INDESIT company

Model type:
LI700PLUS

Commercial code:
F037872

n1045136: introduction of new high pressure sensor

N1045136FIG1

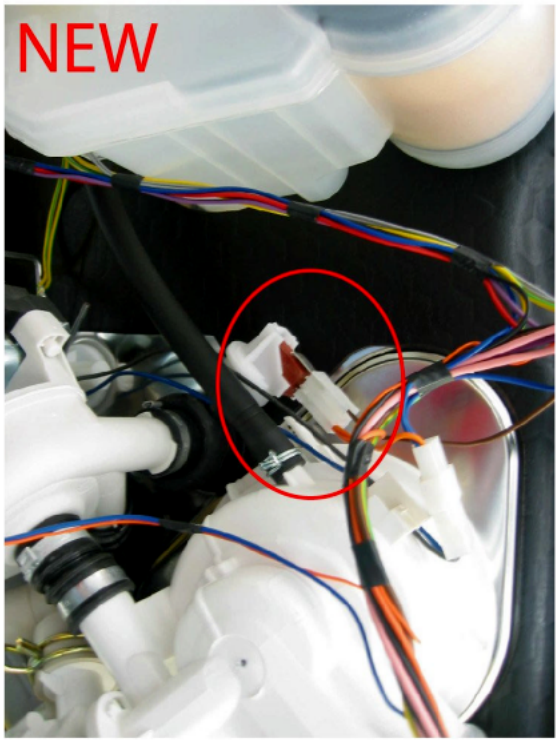
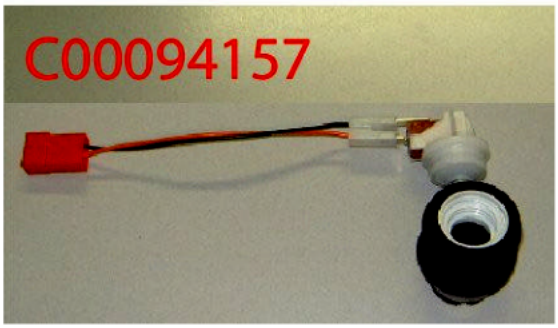
In modified products the connector going to the high pressure sensor is part of the wiring assembly (see picture N1045136FIG1).
In premodification products the high pressure sensor is connected to the wiring assembly by a cable that is part of code C00094157 (see pictures N1045136FIG2-3).

The new parts are not individually interchangeable with premodification ones.

New parts
Wiring
C00142435 - high pressure sensor

Premodification parts
Wiring
C00094157 - high pressure sensor + cable
